LR-N15-0239

Salem Generating Station, Units 1 and 2
Renewed Facility Operating License Nos. DPR-70 and DPR-75
NRC Docket Nos. 50-272 and 50-311

Subject: Salem Generating Station Unit 2 Compliance with March 12, 2012 NRC Order to Modify Licenses with Regard to Reliable Spent Fuel Pool Instrumentation (Order Number EA-12-051) and Responses to Requests for Additional Information for Salem Units 1 and 2

Attachment 2 – Salem Generating Station Units 1 and 2 Response to Interim Staff Evaluation and Request for Additional Information Regarding the Overall Integrated Plan for Implementation of Order EA-12-051, Reliable Spent Fuel Pool Instrumentation

Figure 1 - Typical Mounting Sketch (Not to scale)
Ref: PSEG Drawing 606366

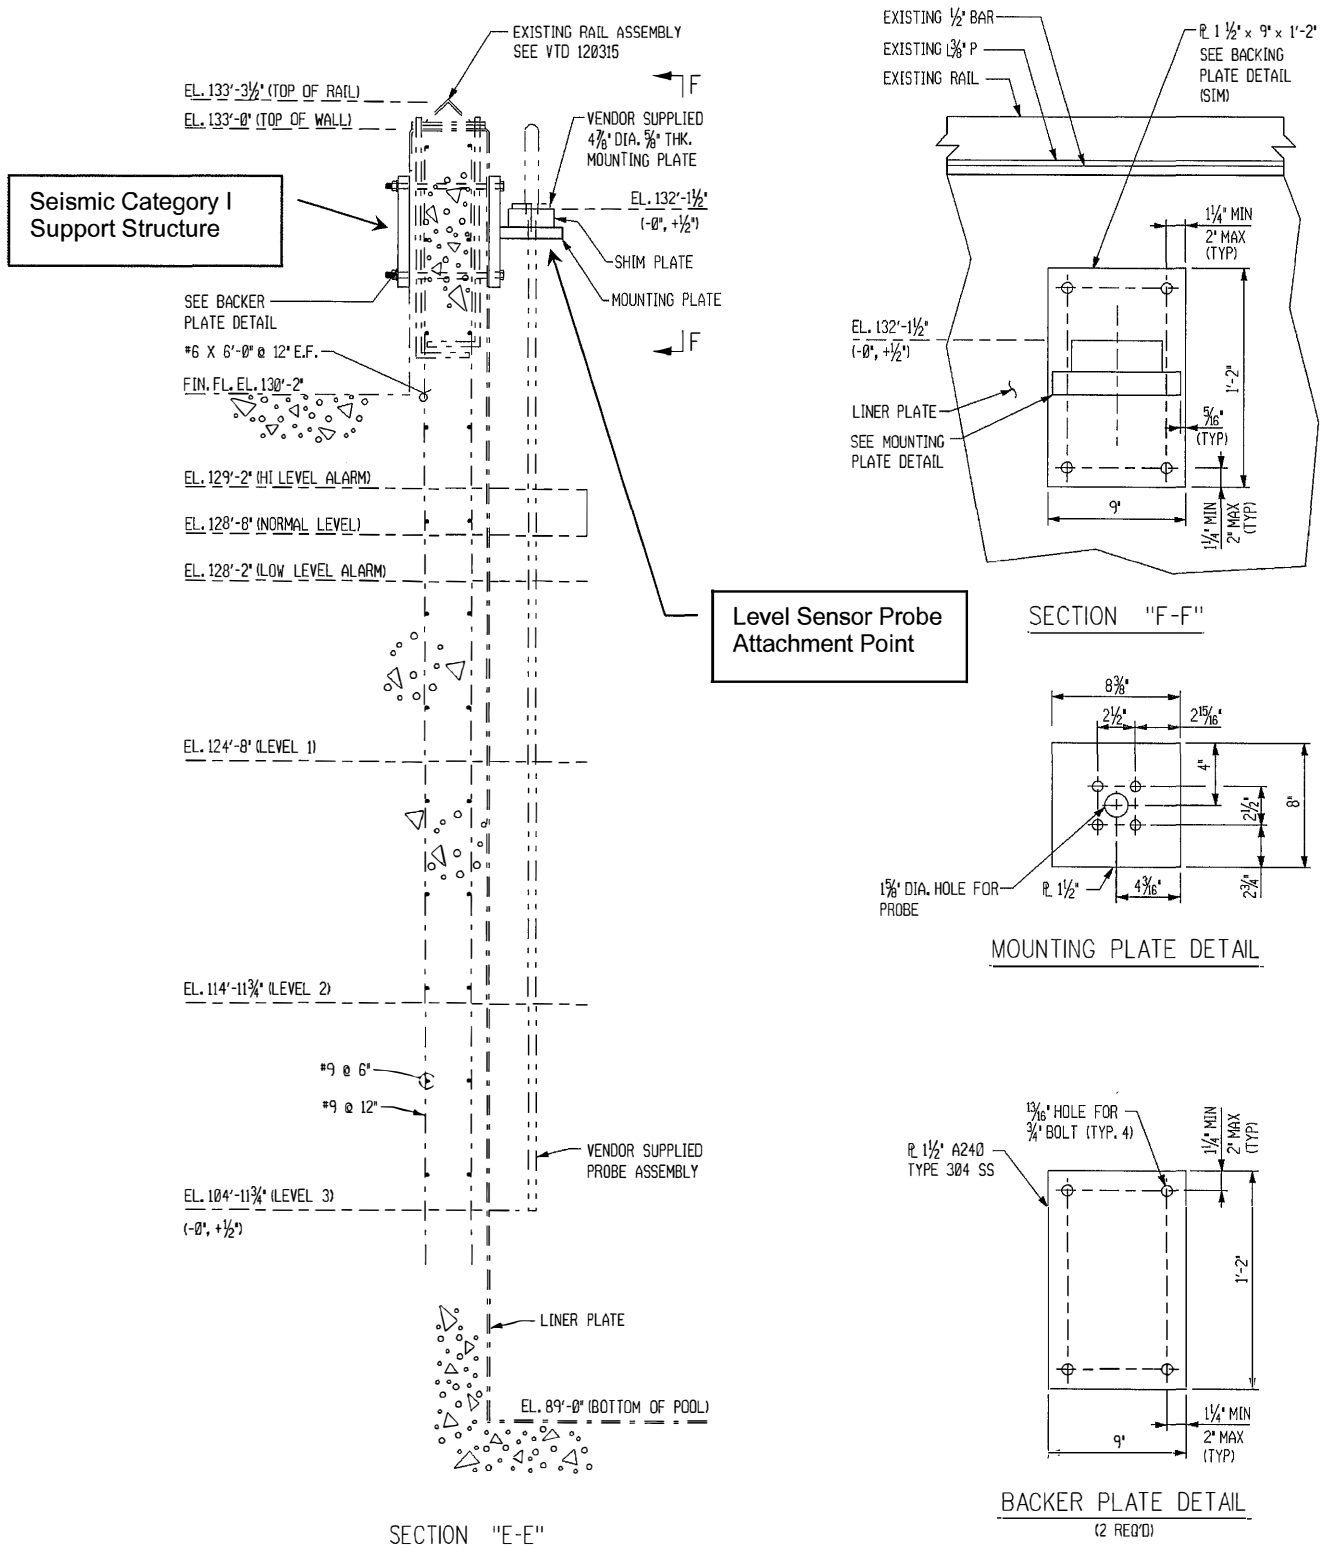
- b) A description of the manner in which the level sensor (and stilling well, if appropriate) will be attached to the refueling floor and/or other support structures for each planned point of attachment of the probe assembly. Indicate in a schematic the portions of the level sensor that will serve as points of attachment for mechanical/mounting or electrical connections.

- c) A description of the manner by which the mechanical connections will attach the level instrument to permanent SFP structures so as to support the level sensor assembly.

- b) Each level sensor is mounted to a support structure that is designed to Seismic Category I requirements. Salem is using the Mohr EFP-IL design, which does not include a stilling well. The support structure is anchored to the concrete curb around the SFP above the refueling deck as shown in Figure 1. The anchorage of the level probe mount is analyzed for Seismic Category I requirements in accordance with the SGS Units 1 and 2 structural design criteria (Reference 3), and documented in SGS calculation 6S0-2345 (Reference 4).
- c) The level sensor is designed to be attached near its upper end to the Seismic Category I support structure designed specifically to fit the SGS Unit 1 and 2 SFPs as shown in Figure 1.
